3.4 SPECIFIC DESIGN REQUIREMENTS — STRUCTURAL PADS

MANDATORY APPENDIX I

AMBIENT-TEMPERATURE TEMPER BEAD WELDING

FIG. 1 STRUCTURAL PAD

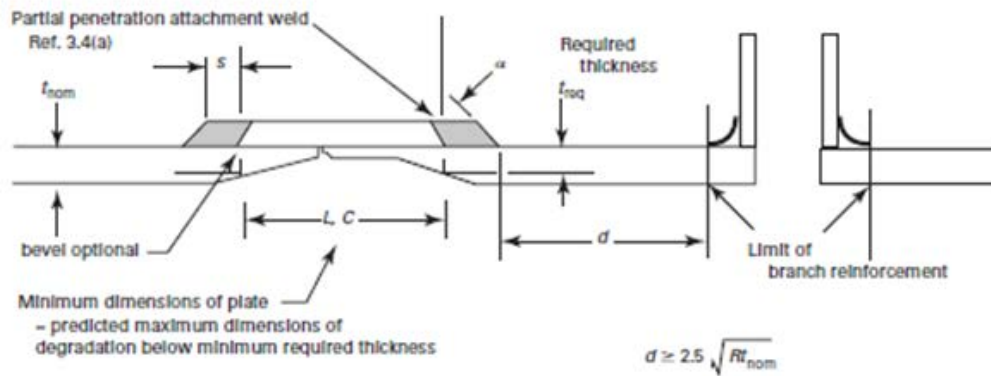
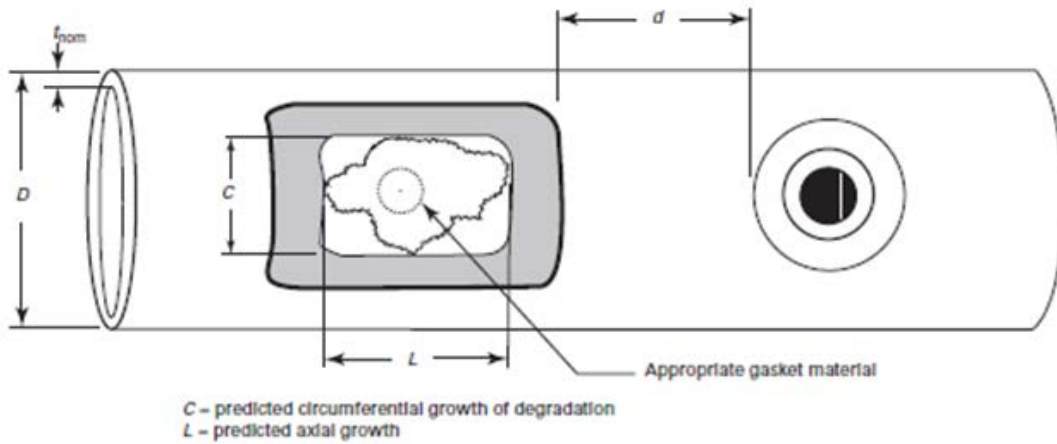
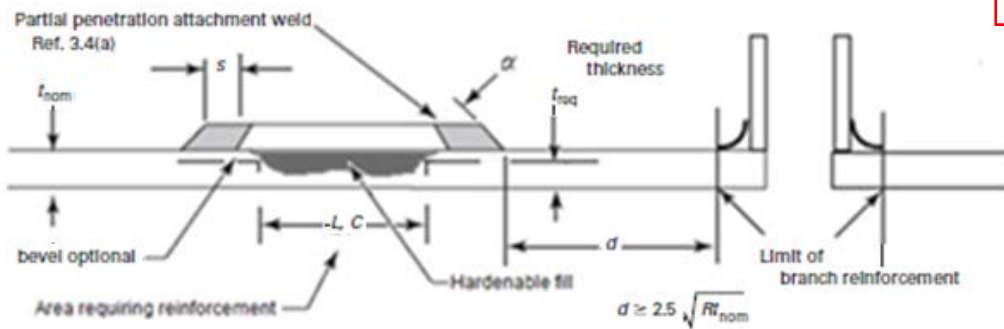
Replace with (a) and (b) on next page

Insert figures (a) and (b)

(a) Mitigation of Internal Corrosion

(b) Mitigation of External Corrosion

FIG. 1 STRUCTURAL PAD

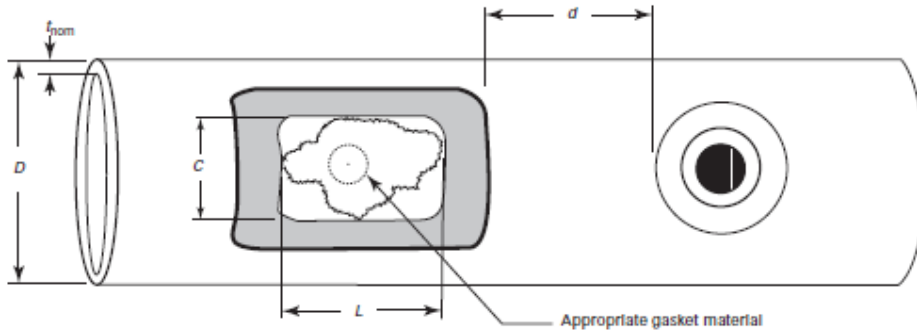
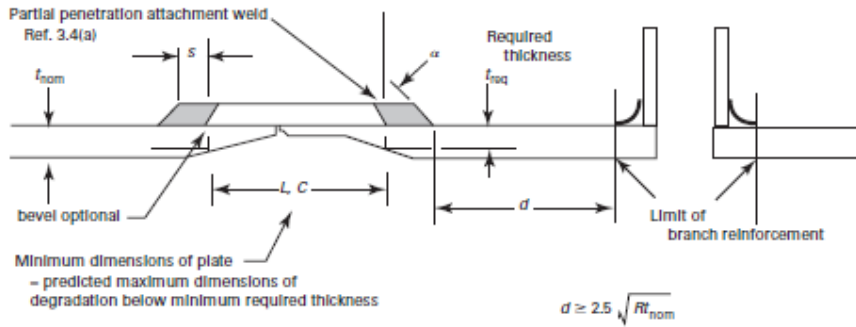
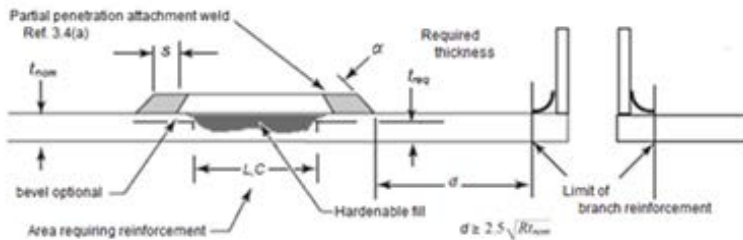
Unless otherwise established by analysis in accordance with the requirements of 3.2(a), ~~structural pads shall be attached by partial penetration attachment welds (see Fig. 1) that extend for a distance of at least s in each direction beyond the area predicted, by the next refueling outage, to infringe upon the required thickness^{2,3}~~

(changed from 2 to 3)

Changed from 2 to 3

(a) Structural pads shall be attached by partial-penetration welds (see Fig. 1) that, unless

thickness,³ where

$s \geq 0.75\sqrt{Rt_{nom}}$

$s \geq 1 \text{ in. (25 mm)}$

$R = D/2 =$ outer radius of the component

$t_{nom} =$ nominal wall thickness of the component
